<p>This Site Memorandum confirms a variation of the Works following oral instructions, an inspection of site operations or the issuance of new or revised documents for construction. Unless stated otherwise, it shall be treated as an Instruction to carry out works as authorised by Architects Instruction F-620 dated 12 March 2014. Where applicable, it includes provision for distribution to all relevant members of the client/design/construction team and the Antiquities and Monuments Office.</p>	<p>Site Memorandum No. 987</p> <p>Date: 8th November 2016</p>
--	--

Subject: Non-Compliance, Smoking and Urinating in Block 3 First Floor

This Site Memorandum confirms a variation of the Works following oral instructions, an inspection of site operations or the issuance of new or revised documents for construction. Unless stated otherwise, it shall be treated as an Instruction to carry out works as authorised by Architects Instruction F-620 dated 12 March 2014. Where applicable, it includes provision for distribution to all relevant members of the client/design/construction team and the Antiquities and Monuments Office.	<p style="margin: 0;">Site Memorandum No. 1011</p> <p style="margin: 0;">

Above, photo taken on 30th July 2009, dotted line showing the Transfer Gate "A" within A Hall Yard.

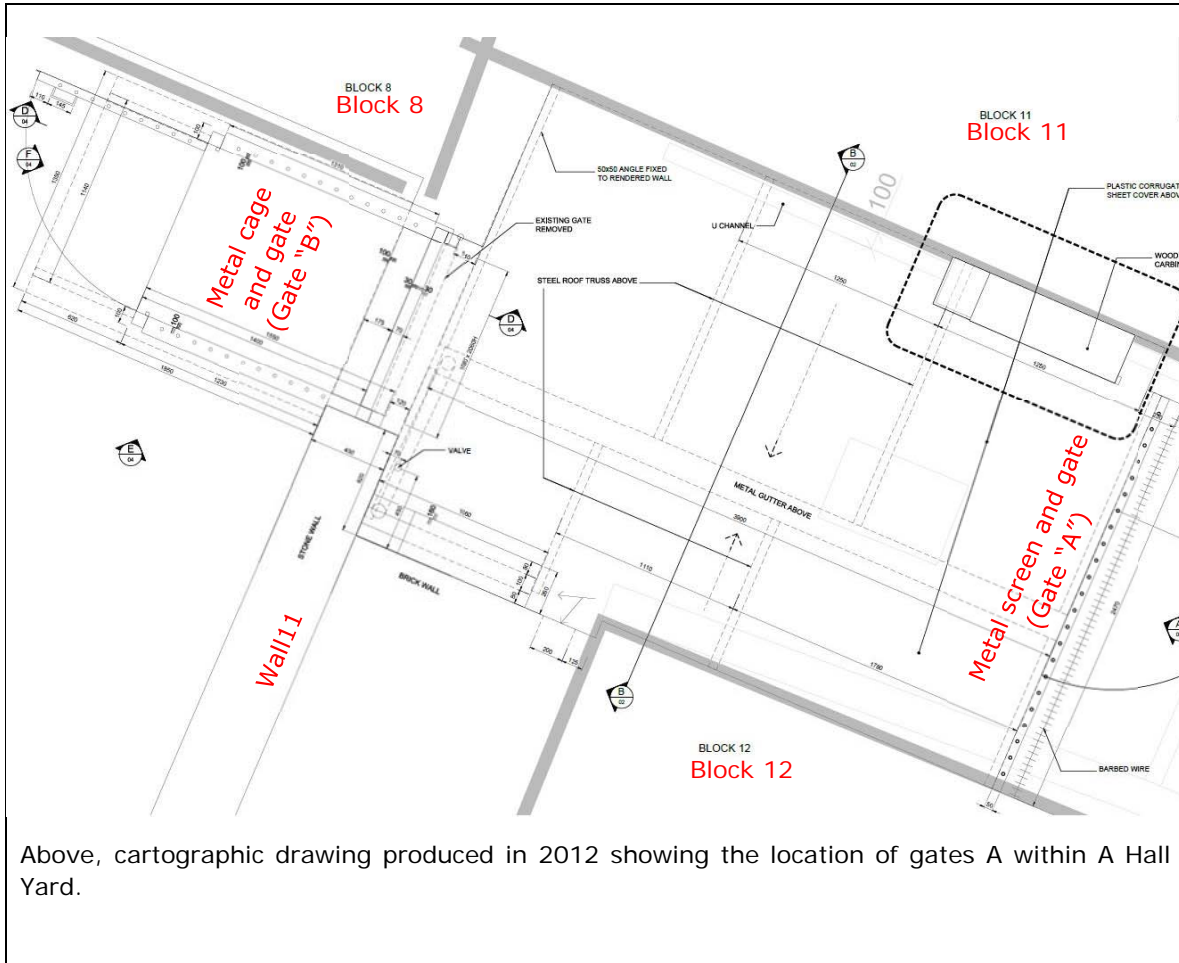
<p>This Site Memorandum confirms a variation of the Works following oral instructions, an inspection of site operations or the issuance of new or revised documents for construction. Unless stated otherwise, it shall be treated as an Instruction to carry out works as authorised by Architects Instruction F-620 dated 12 March 2014. Where applicable, it includes provision for distribution to all relevant members of the client/design/construction team and the Antiquities and Monuments Office.</p>	<p>Site Memorandum No. 1053</p> <p>Date: 18th May 2017</p>				
<p>To: Gammon Construction Limited For the attention of: Cliff Leung</p>					
<p>Subject: Non-compliance, Loss of Gate/Fence "A" in A Hall Yard</p>	<p>A.I. no: F-620</p>				
<p>It was reported by the Management Contractor on 13th March 2017 that Gate/Fence "A" located within A Hall Yard has been lost. (Refer to plan overleaf for location and photograph.)</p> <p>The Management Contractor and Works Package Contractors are required to:</p> <ol style="list-style-type: none"> 1. Review and revise the work practices of handling and storing historic building fabric. 2. Supervise the work operations to ensure compliance with the Contract Documents and submit mitigation measures to enhance precautionary and storage measures. 3. Fabricate new metal gate/fence to match the original as per design detailed on Site Memo 1029. <p style="text-align: right;">(Continue over leaf)</p>

<p>Heritage Impact: Historic fabric has been lost.</p> <p>Proposed Mitigation Measures: Instruct Contractor to comply with Contract Documents. Fabricate new metal gate to match original.</p> <p>Justification: N/A</p>					
<p>Variation: N</p> <p>Cost implication: N</p>	<p>LB Cost estimate: HKD Initials: Date:</p>	<p>JCCPS approved/rejected Initials: Date:</p>			
<p>Copies to:</p>					
√	Employer JCCPS	√	Structural Eng Arup		
√	Quantity Surveyor RLB	√	Services Eng JRP	√	Environmental Management ERM
√	Contract Administrator RDA	√	Design Consultant HdM	√	Antiquities & Monuments Office AMO
√	Resident Architect RDA			√	For Purcell
